SUBJECT: Request for minor turbine location changes for the Thunder Spirit Wind Energy Project, Adams County, ND (Case No. PU-11-601)

Attachment 1
Figure – Permitted Turbine Locations Compared to
Base Case Layout

Summary of Footprint Impacts Associated with Redesign of the Thunder Spirit 78 turbine 150MW PSC-permitted Layout
Compared to a 43 turbine 107.5MW Layout

ADMINISTRATIVE UPDATE

Figure A-1
 Permitted Turbine Locations
 Compared to
 Base Case Layout
 Thunder Spirit Wind Energy Project
 Thunder Spirit Wind, LLC
 Adams County, North Dakota
 June 2014

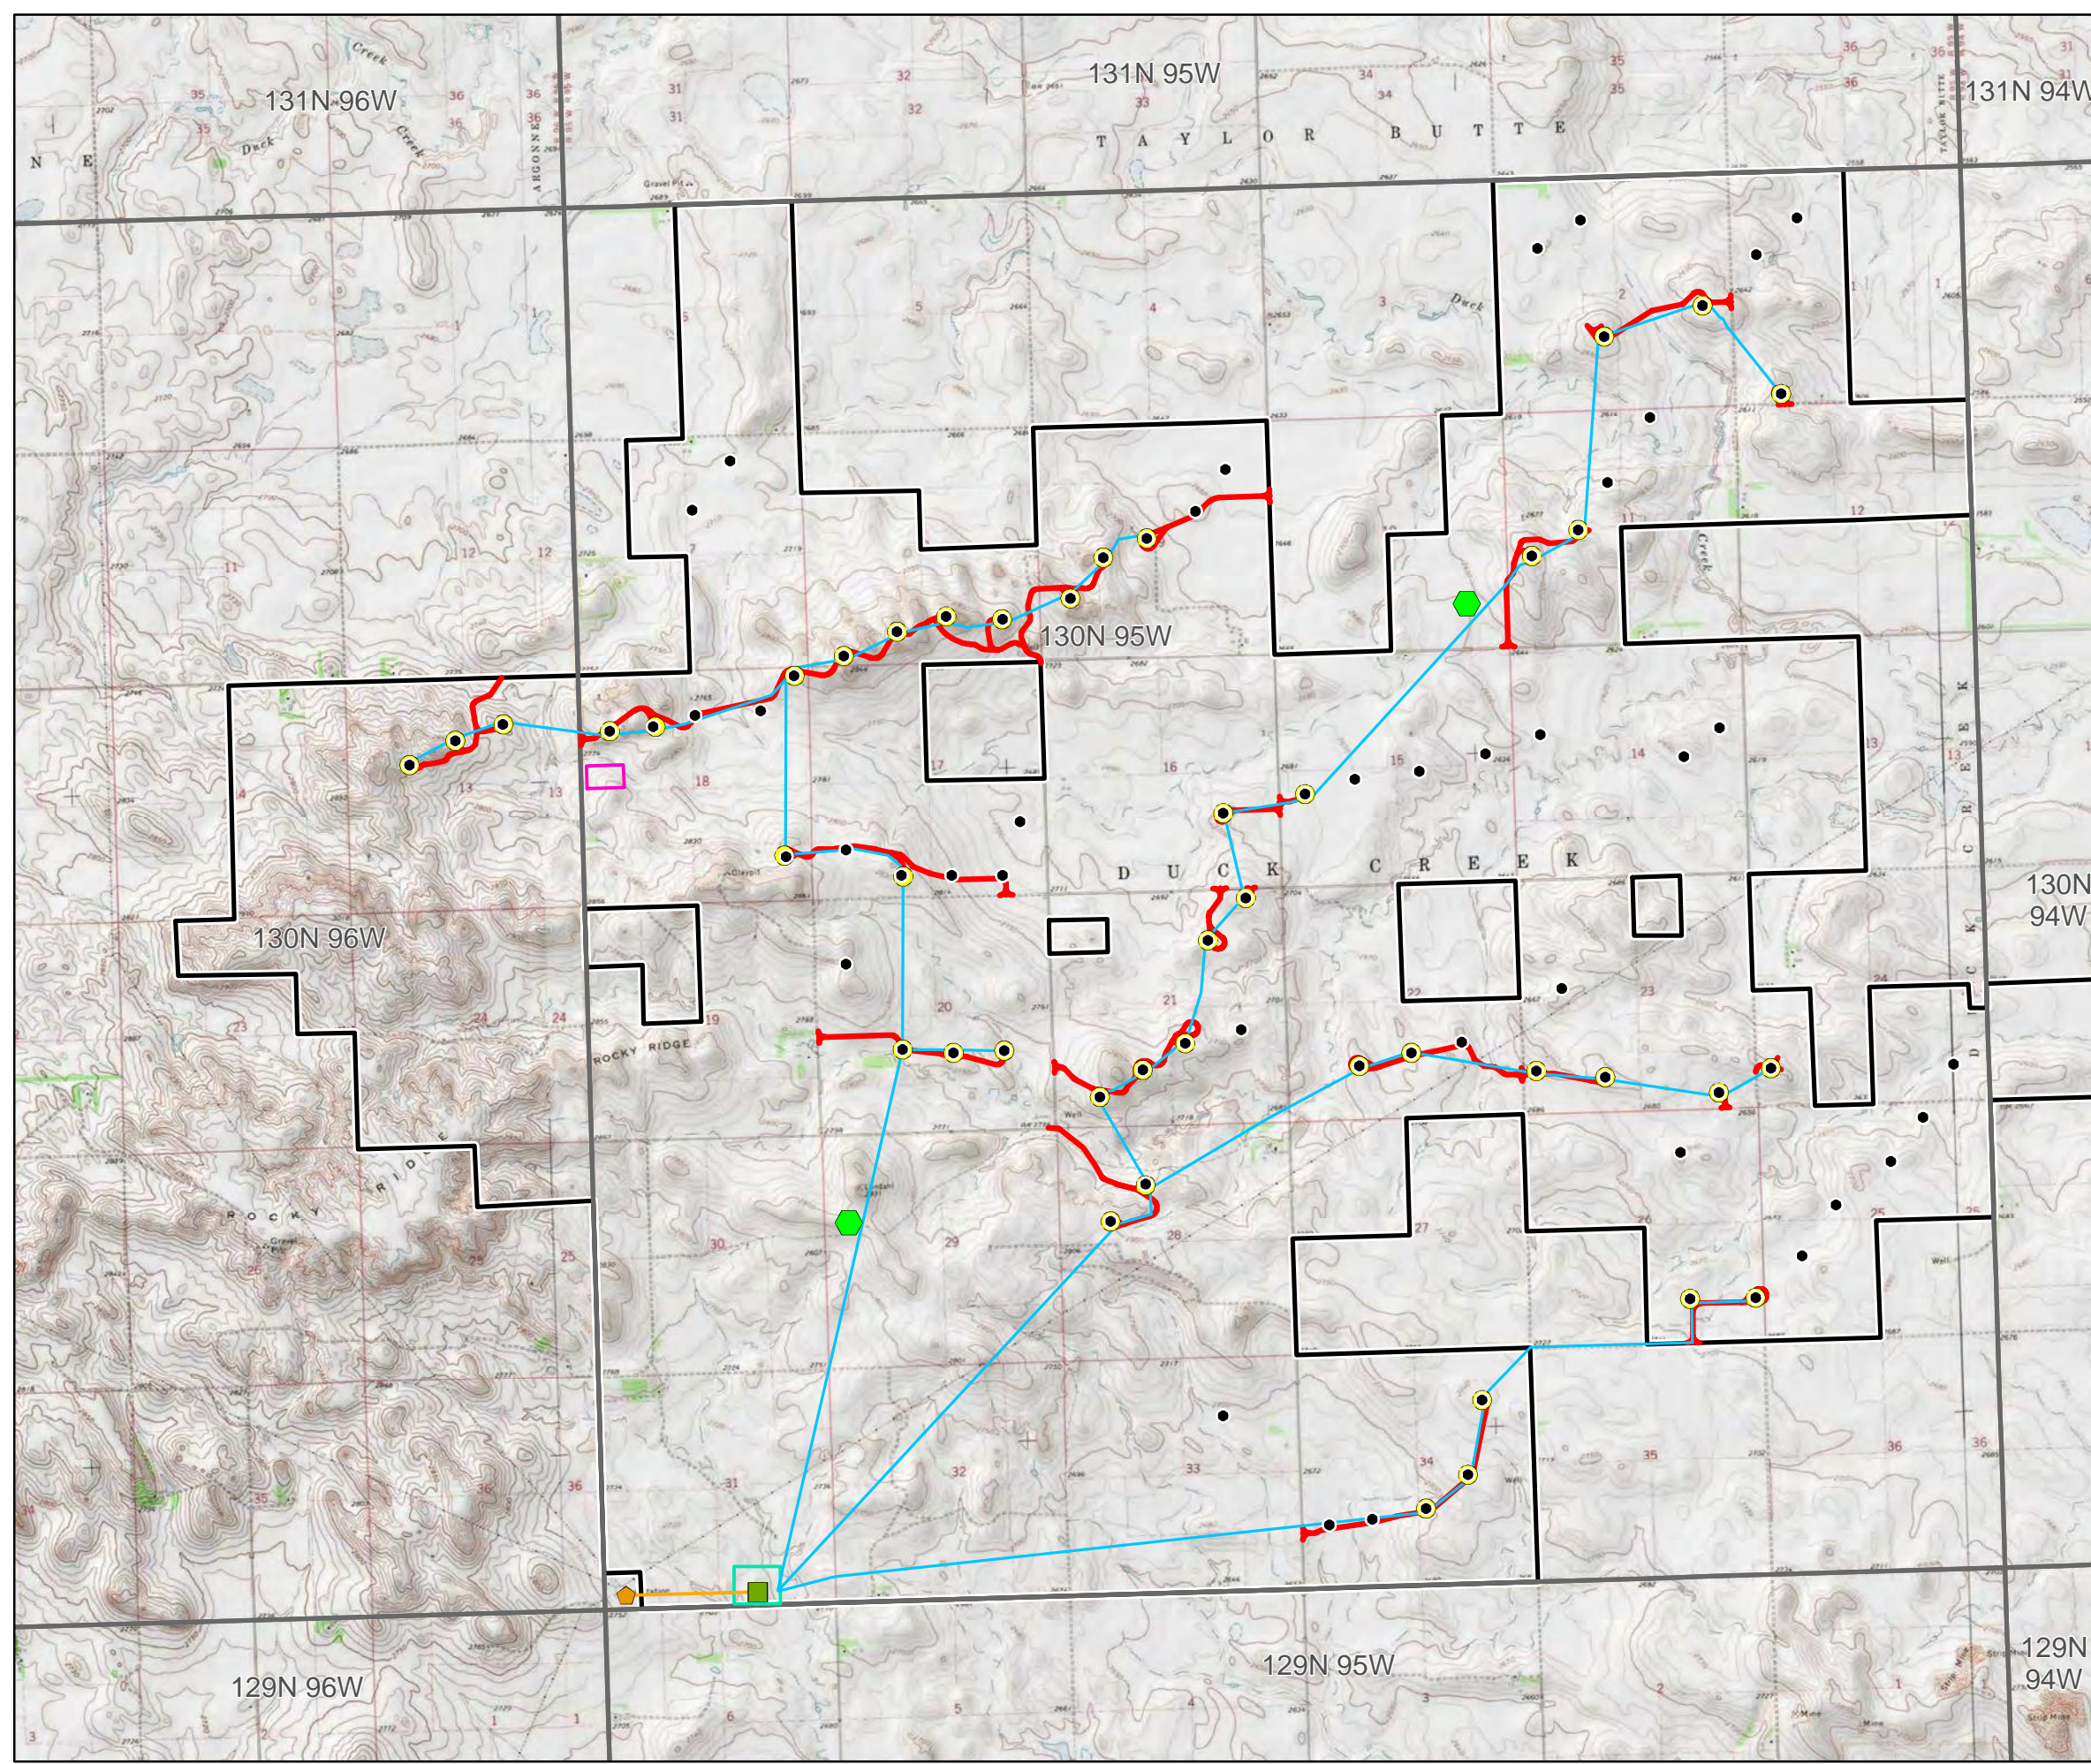
Those modifications treated within this application apply to a 43 turbine "Base Case Layout," which consists of a subset of the originally permitted turbines, with minor corresponding changes to roads and collection lines. *Refer to the figure in Attachment 1 which depicts the Permitted Turbine Locations Compared to Base Case Layout and the table and figures in Attachment 2 showing the distances and justifications for the minor shifts.*

Project Area (Topographical)
Permitted Layout &
Base Case Layout

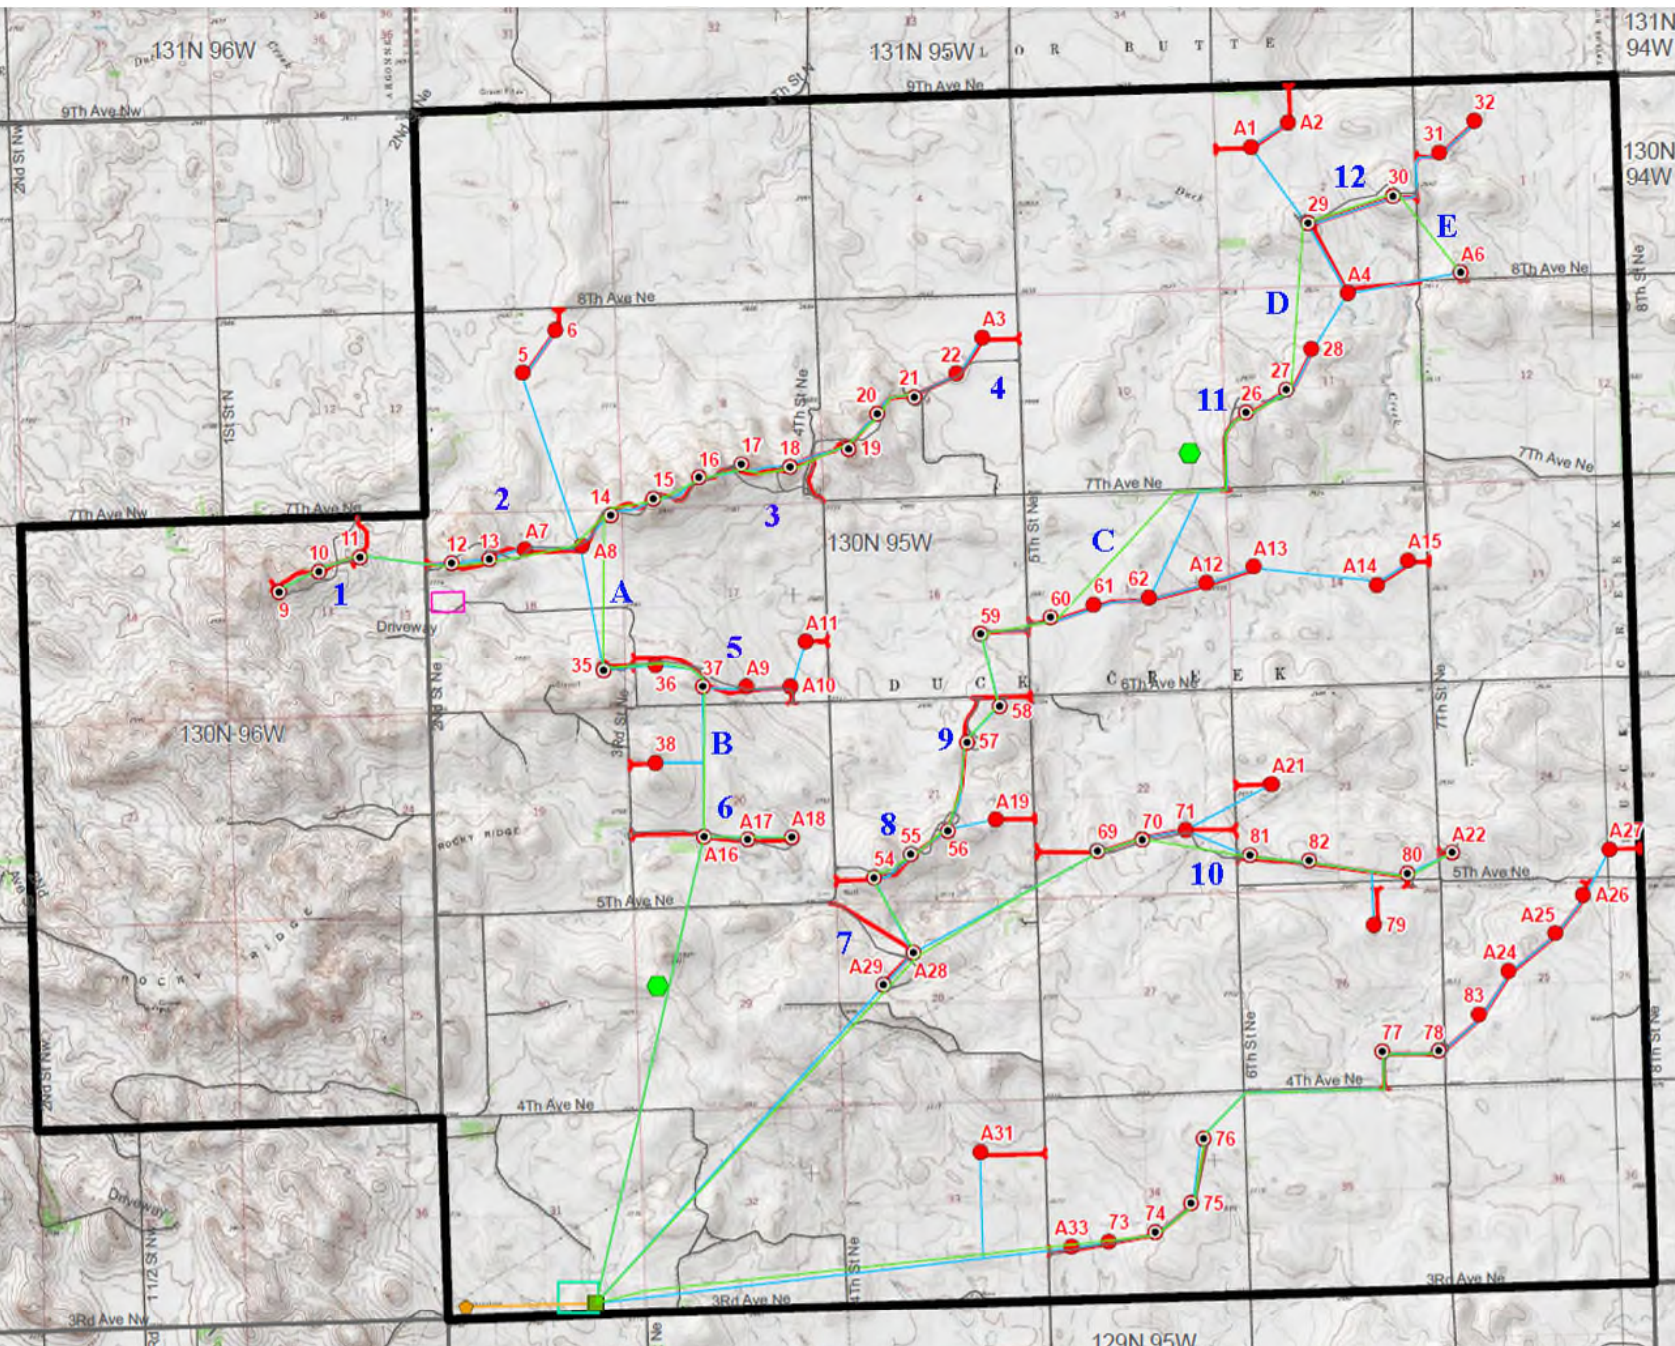
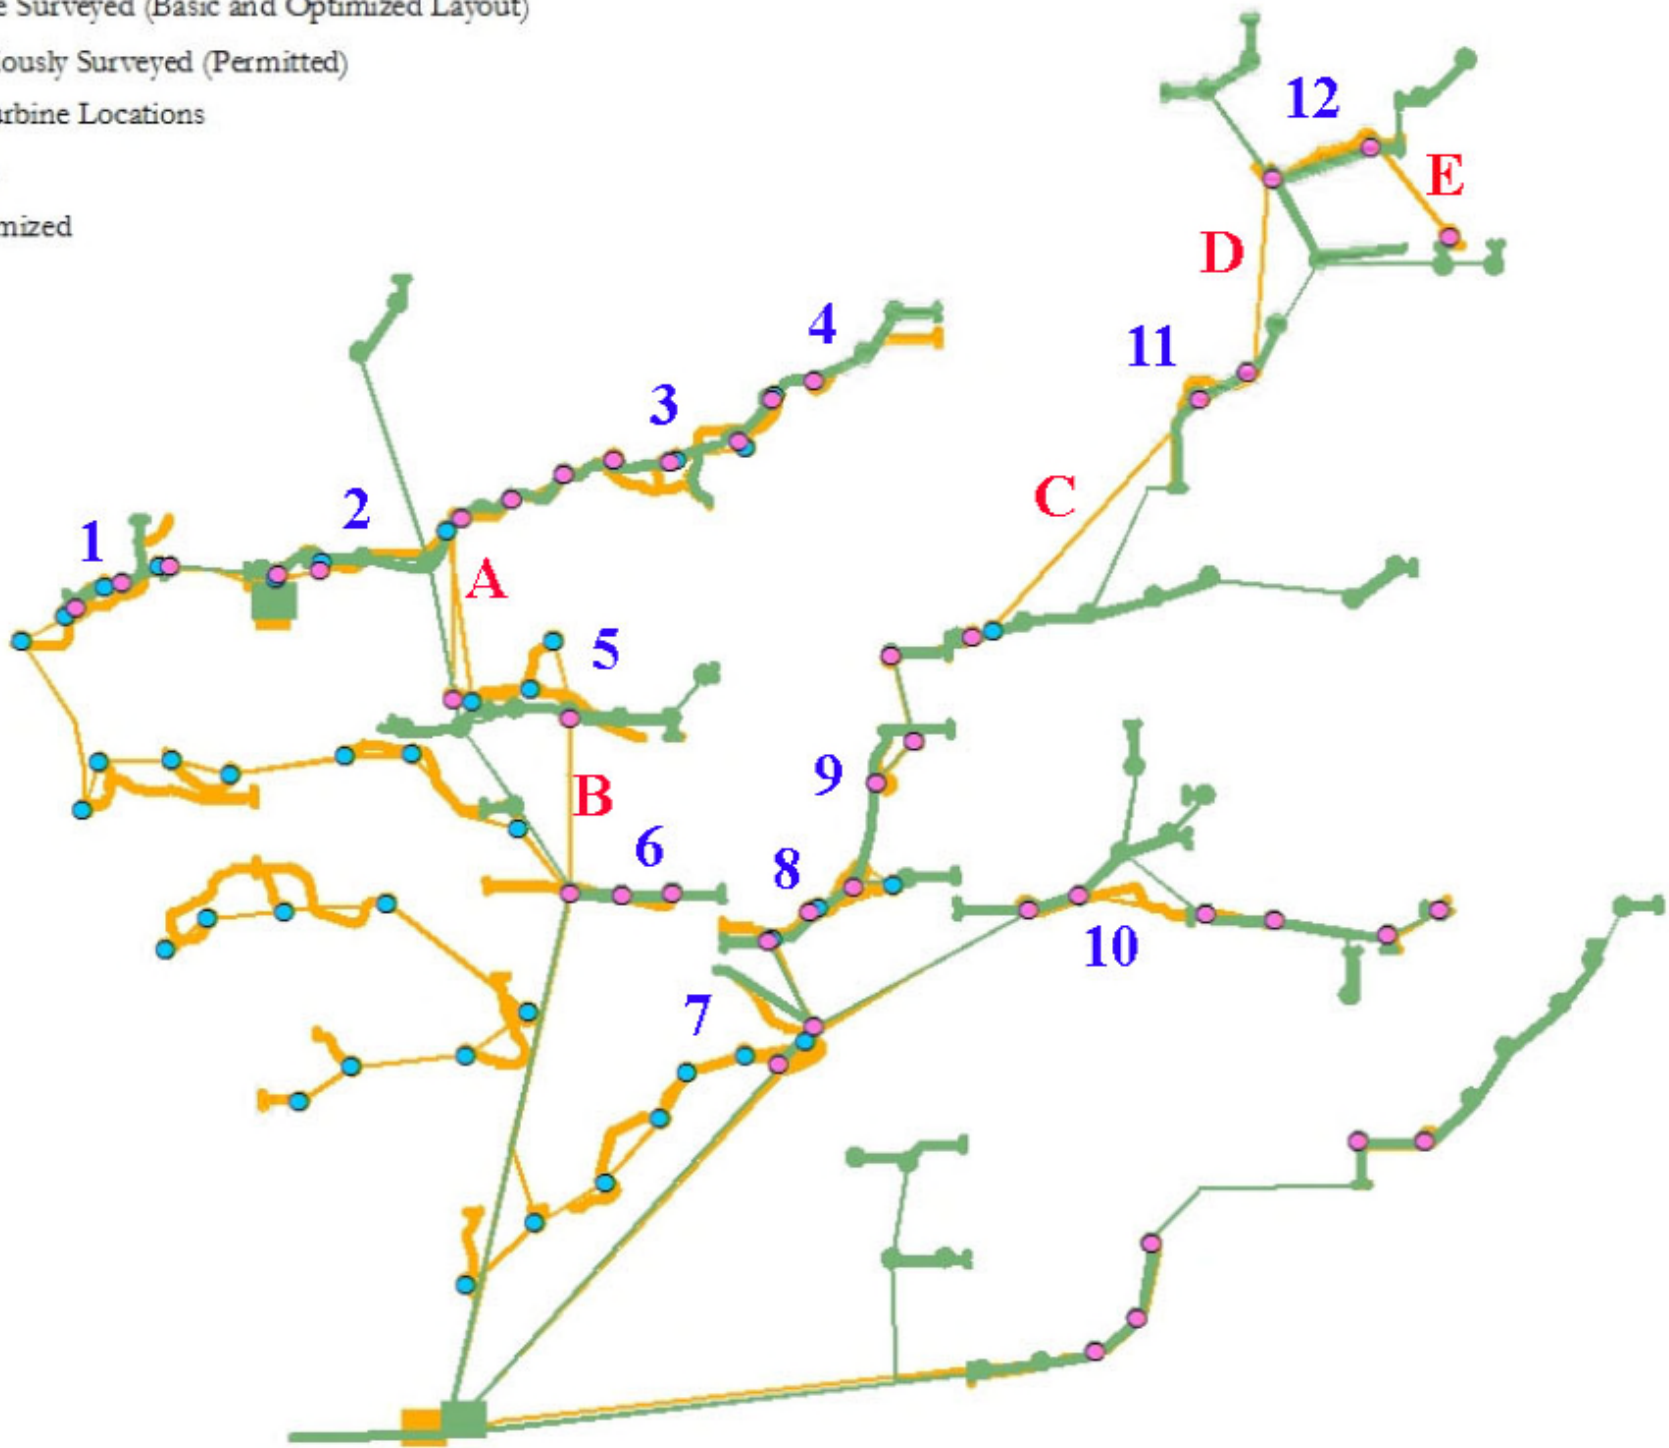
Footprint Impacts due to Turbine Movements		
Turbine Location	Rationale for Realignment	Anticipated impacts
Minor adjustments for 43 turbines	Some minor changes were required to optimize the smaller pool of turbines within the overall layout (<i>Note that all 43 turbines remain within 5 ft of their 2013 permitted locations</i>)	Other than impacts due to the loss of footprint, no new impacts to sensitive resources versus permitted layout have been identified. Please see Attachment 3 for information on the PSC siting criteria which depicts that there are no new cultural, wetland, shadow flicker, or sound impacts.
Footprint Impacts due to Road Realignments		
Road Location (turbine associations)	Rationale for Realignment	Anticipated impacts

1. T9-T11	<ul style="list-style-type: none"> • compliance with Nordex transport specs • reduction in cut/fill work (improved erosion/sediment control) 	Other than impacts due to the loss of footprint, no new impacts to sensitive resources versus permitted layout have been identified. Please see Attachment 3 for information on the PSC siting criteria which depicts that there are no new cultural, wetland, or other impacts due to road realignment.

2. T12-T13	<ul style="list-style-type: none"> • design change required by 43 turbine layout • avoidance of sensitive resource (cultural) • compliance with Nordex transport specs • reduction in cut/fill work (improved erosion/sediment control)

3. T17-T19	<ul style="list-style-type: none"> • compliance with Nordex transport specs • reduction in cut/fill work (improved erosion/sediment control)

4. T21	<ul style="list-style-type: none"> • design change required by 43 turbine layout • compliance with Nordex transport specs 	
5. T37	<ul style="list-style-type: none"> • design change required by 43 turbine layout • compliance with Nordex transport specs

6. TA16-TA18	<ul style="list-style-type: none"> • reduction in cut/fill work (improved erosion/sediment control) • compliance with Nordex transport specs

7. TA28-TA29	<ul style="list-style-type: none"> • reduction in cut/fill work (improved erosion/sediment control) • compliance with Nordex transport specs

8. T54-T56	<ul style="list-style-type: none"> • design change required by 43 turbine layout • compliance with Nordex transport specs • reduction in cut/fill work (improved erosion/sediment control)

9. T57	<ul style="list-style-type: none"> • design change required by 43 turbine layout • compliance with Nordex transport specs

Footprint Impacts due to Road Realignments (continued)		
10. T70-T81	<ul style="list-style-type: none"> design change required by 43 turbine layout compliance with Nordex transport specs 	Other than impacts due to the loss of footprint, no new impacts to sensitive resources versus permitted layout have been identified. Please see Attachment 3 for information on the PSC siting criteria which depicts that there are no new cultural, wetland, or other impacts due to road realignment.

11. T26	<ul style="list-style-type: none"> design change required by 43 turbine layout compliance with Nordex transport specs 	
12. T29-T30	<ul style="list-style-type: none"> design change required by 43 turbine layout compliance with Nordex transport specs reduction in cut/fill work (improved erosion/sediment control) 	
Footprint Impacts due to Cable Rerouting		
Cabling Location	Rationale for Realignment	Anticipated impacts

A. T35-T14	<ul style="list-style-type: none"> design change associated with from 78 to 43 turbine layout 	No new impacts to sensitive resources versus permitted layout have been identified. Please see Attachment 3 for information on the PSC siting criteria which depicts that there are no new cultural, wetland, or other impacts due cable realignment.

B. TA16-T37	<ul style="list-style-type: none"> design change associated with from 78 to 43 turbine layout 	
C. T60-T26	<ul style="list-style-type: none"> design change associated with from 78 to 43 turbine layout

D. T27-T29	<ul style="list-style-type: none"> design change associated with from 78 to 43 turbine layout 	
E. T30-TA6	<ul style="list-style-type: none"> design change associated with from 78 to 43 turbine layout
